Access Compliance Report

Public Rights-of-Way

(Pedestrian Signals)

Intersection ID: N/A	Main Street:	Cross Street: N/A	Location: N/A
ADA ID: 7E40EDA2C9F3	Signal Type: Two Push Buttons-Non APS	Overall Compliance: No	Severity Score: BTN 1:N/A BTN 2: N/A No BTN: N/A
Codes/Mitigation Info/Possible Solution		Field Measurements/Component Compliance

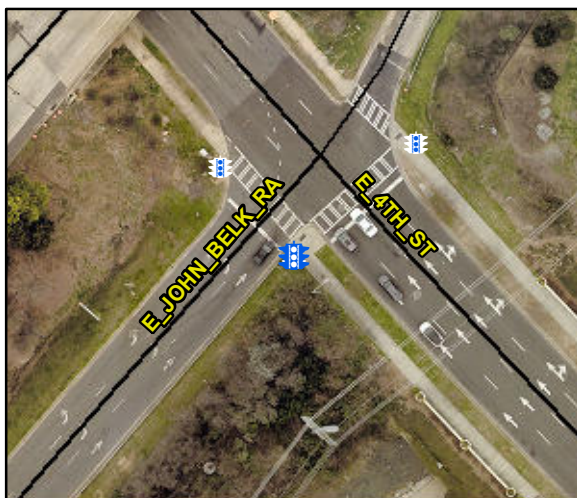
PROW/ADA: TMUTCD 4e.08, R404.2, R404.3, R404.7.3, R406.2

Compliance	Description	Data	Compliance	Description	Data
	Button Count	Button2	N/A	Distant to Additional Button (in)	N/A
	Additional Button Present?	No		Additional Button ID	N/A
N/A	Signal Buttons Required?	N/A	N/A	Additional Ped Posts Required	N/A
	How Many Ped Street Xings?	2		Located In An Island/Median?	No
N/A	B 1 Sign Present?	Yes	N/A	B 2 Sign Present?	Yes
Yes	B 1 Sign Purpose?	Yes	Yes	B 2 Sign Purpose?	Yes
Yes	B 1 Sign Lettering & Contrast?	Yes	Yes	B 2 Sign Lettering & Contrast?	Yes
Yes	B 1 Parallel To XWalk?	Yes	Yes	B 2 Parallel To XWalk?	Yes
Yes	B 1 PAR to Button?	Yes	Yes	B 2 PAR to Button?	Yes
Yes	B 1 PAR to XWalk?	Yes	Yes	B 2 PAR to XWalk?	Yes
Yes	B 1 Clear Floor Space?	Yes	Yes	B 2 Clear Floor Space?	Yes
N/A	B 1 FWD Approach?	No	N/A	B 2 FWD Approach?	Yes
N/A	B 1 FWD Approach Constrained?	N/A	N/A	B 2 FWD Approach Constrained?	No
N/A	B 1 FWD Approach Reach (in)	N/A	No	B 2 FWD Approach Reach (in)	13.0

N/A	B 1 FWD Approach Width (in)	N/A	N/A	B 2 FWD Approach Width (in)	N/A
N/A	B 1 FWD Approach Obstruction?	N/A	N/A	B 2 FWD Approach Obstruction?	Yes
N/A	B 1 FWD Approach Obstruction Dist (in)	N/A	N/A	B 2 FWD Approach ObstructionDist (in)	8.0
N/A	B 1 PARA Approach?	Yes	N/A	B 2 PARA Approach?	Yes
N/A	B 1 PARA Approach Constrained?	No	N/A	B 2 PARA Approach Constrained?	No
No	B 1 PARA Approach Reach (in)	18.0	No	B 2 PARA Approach Reach (in)	13.0
N/A	B 1 PARA Approach Width (in)	N/A	N/A	B 2 PARA Approach Width (in)	N/A
N/A	B 1 PARA Approach Obstruction?	Yes	N/A	B 2 PARA Approach Obstruction?	Yes
N/A	B 1 PARA Approach Obstruction Dist (in)	9.0	N/A	B 2 PARA Approach ObstructionDist (in)	8.0
No	B 1 Clear Floor Space Slope (%)	3.2	No	B 2 Clear Floor Space Slope (%)	3.8
No	B 1 Clear Floor Space XSlope (%)	4.5	No	B 2 Clear Floor Space XSlope (%)	3.2
N/A	B 1 PAR Slope (%)	2.1	N/A	B 2 PAR Slope (%)	0.7
Yes	B 1 Height (in)	33.0	Yes	B 2 Height (in)	33.0

Yes	B 1 Clear Xing Direction?	ClearlyMarked	Yes	B 2 Clear Xing Direction?	ClearlyMarked
	B 1 Crossing Direction	To NE		B 2 Crossing Direction	To NW
Yes	B 1 DistanceTo XWalk (in)	3.0	No	B 2 DistanceTo XWalk (in)	68.0
No	B 1 DistanceTo Curb (in)	216.0	No	B 2 DistanceTo Curb (in)	101.0
Yes	B 1 Diameter (in)	2.0	Yes	B 2 Diameter (in)	2.0

Possible Solutions: Replace Signal Push Button With APS Button on New Post. Remove & Relocate Sign.
